#### **Addendum 133 – UN Regulation No. 134**

#### **Amendment 4**

#### **Uniform provisions concerning the approval of motor vehicles and their components with regard to the safety-related performance of Hydrogen-Fuelled Vehicles (HFCV)**

Model A

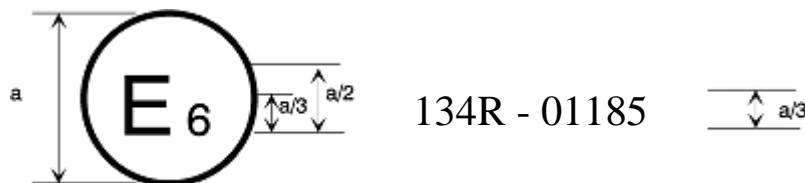
*Annex 2*, amend to read:

(See paragraphs 4.4. to 4.4.2. of this Regulation)

a = 8 mm min

The above approval mark affixed to a vehicle/ storage system/specific component shows that the vehicle/storage system/specific component type concerned has been approved in Belgium (E 6) for its the safety-related performance of hydrogen-fuelled vehicles pursuant to UN Regulation No. 134. The first two digits of the approval number indicate that the approval already contained the 01 series of amendments at the time of approval.
